AUTHORIZATION TO CONDUCT STREAM ALTERATION ACTIVITIES

Project Number: **SA-3-** 105 **-2016**

1. This project authorizes the relocation of a municipal ww treated effluent outfall.
2. The proposed activity is eligible for coverage under the VT ANR Stream Alteration General Permit.

PROPOSED OUTFALL PLAN AND PROFILE STATION 0+00 TO 6+23

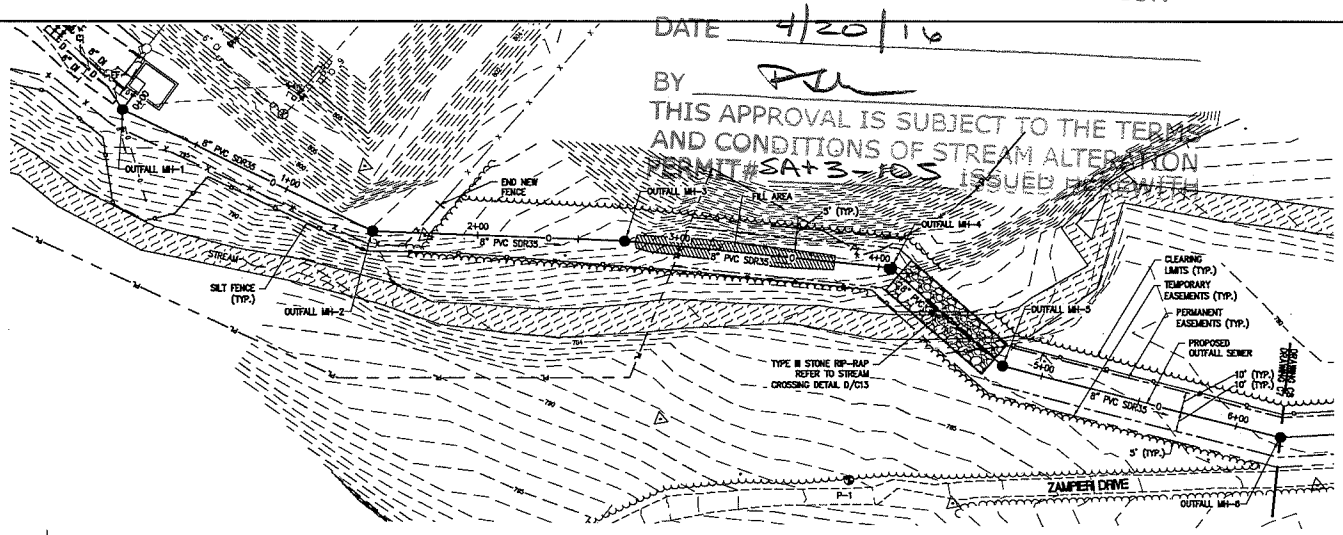
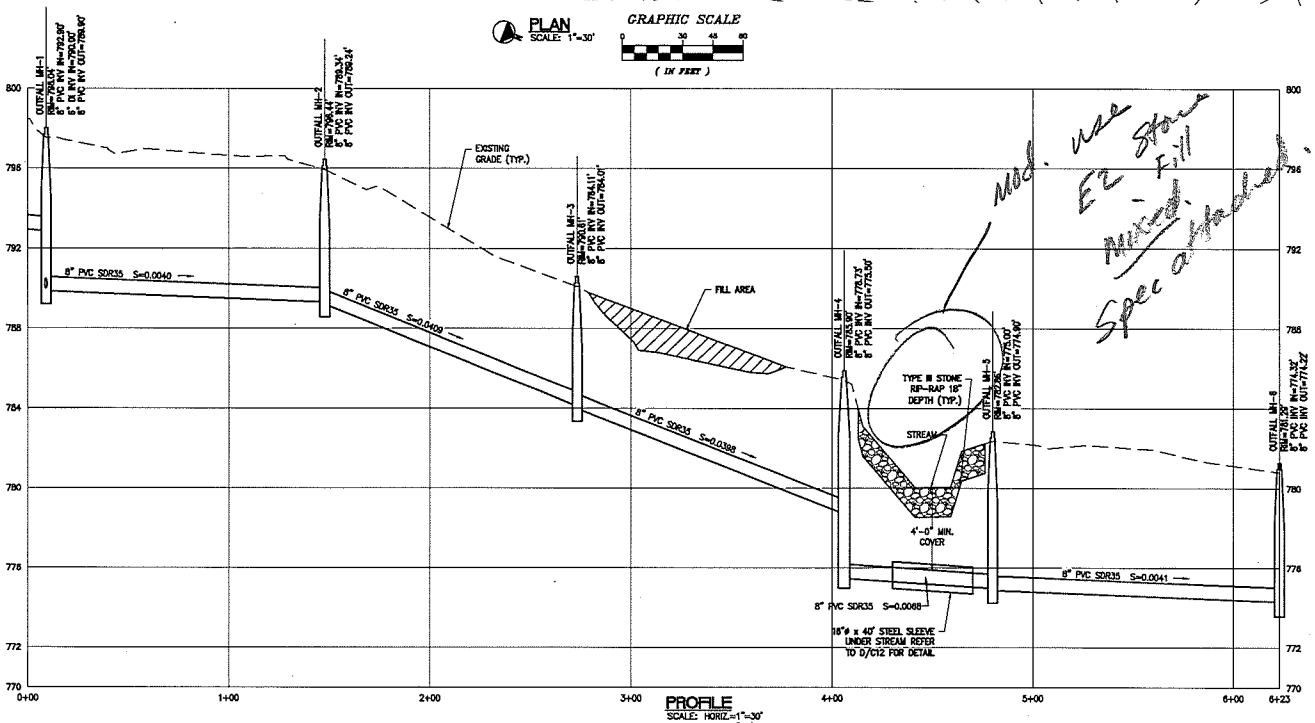
mod. use E2 Stone Fill - mixed. Spec attached.

Type E2. The longest dimension of the stone shall be at least 24 inches, and at least 50 percent of the volume of the stone in place shall have a least dimension of 18 inches, and at least 25 percent of the particles shall have a maximum dimension of 2 inches and be well graded material.

PROPOSED OUTFALL PLAN AND PROFILE STATION 6+23 TO 13+56

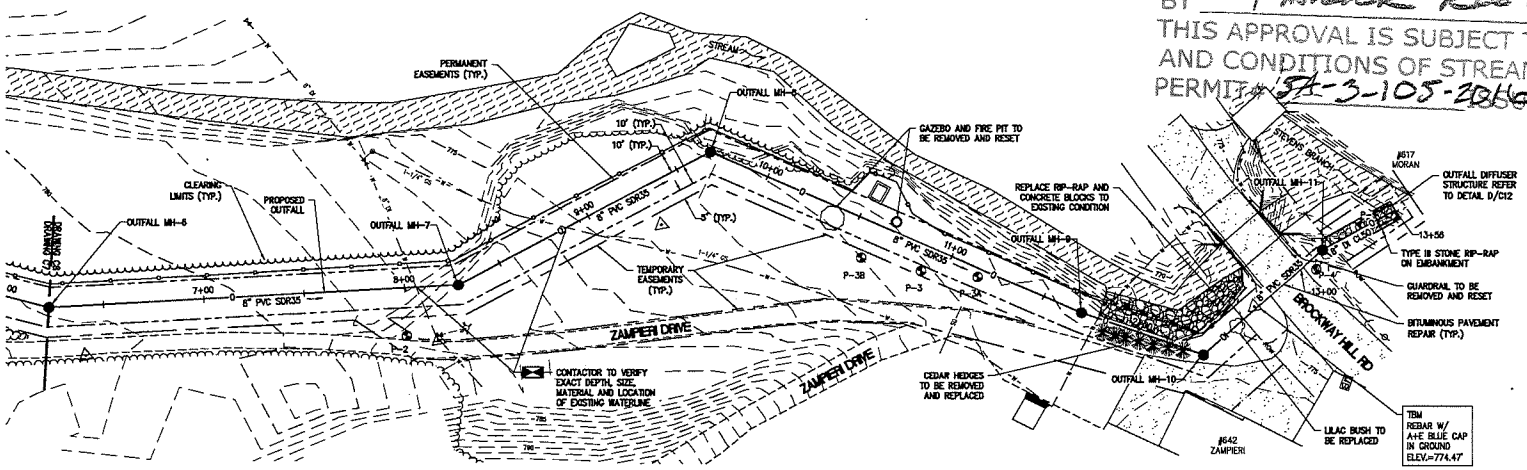
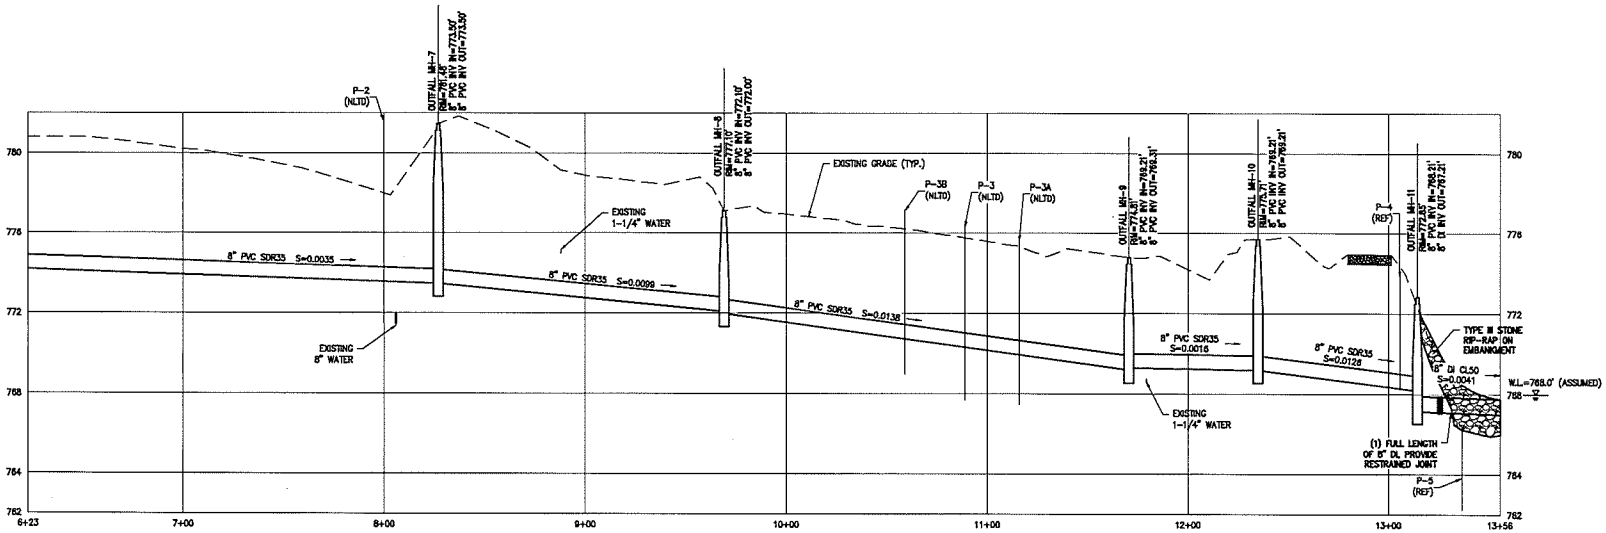
- Instream construction should be limited to the period of June 1 – Oct 1 to protect wild brook trout reproduction within the Stevens Branch and its tributary.
- The restoration of the stream channel where pipeline crossings are proposed should include a gradation of materials, including fines, as required for bed armor treatments. Currently the proposal calls for Type III stone. Streambed and channel roughness characteristics should match adjacent sections of the unaltered stream upon completion.
